CRMC DECISION WORKSHEET

2021-03-090

STATE OF RHODE ISLAND
COASTAL RESOURCES MANAGEMENT COUNCIL
STAFF REPORT TO THE COUNCIL

Applicant's Name:	RI Commerce Corporation
CRMC File Number:	2021-03-090
Project:	Construct a 21.9 acre paved port lay down area, removal of a portion of Thompson Rd and relocation further inland, wetland restoration, stormwater management, public access
Location:	Thompson Road; North Kingstown: Plat(s): 192; Lot(s): 10, 9, 8, 7, 5, 2
Water Type/Name:	6, Narragansett Bay
Coastal Feature:	Coastal Beach, Coastal Wetland
Freshwater Feature:	Wooded Swamp, 50 foot Buffer, Stream, 100 foot Buffer
Coastal Feature:	Coastal Wetland
Plans Reviewed:	"QUONSET MULTIMODAL OFFSHORE WIND TRANSPORT CENTER (QMTC) AT QUONSET BUSINESS PARK" 17 sheets, dated March 2022 and last revised June 2022, by Quonset Development Corporation

Fig 2: Aerial image of small parking area, plan set depicting this parking to remain.

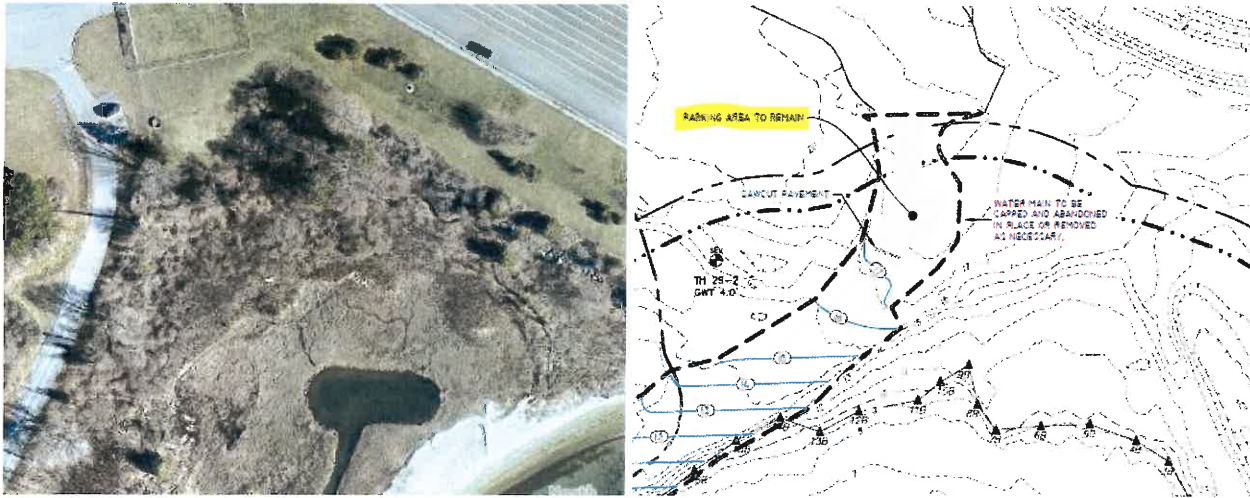
There is a small parking area of four parking spots to the north of the shoreline, which shall remain in place upon removal of Thomson Rd.

It is staff's opinion that the public access requirement has been met.
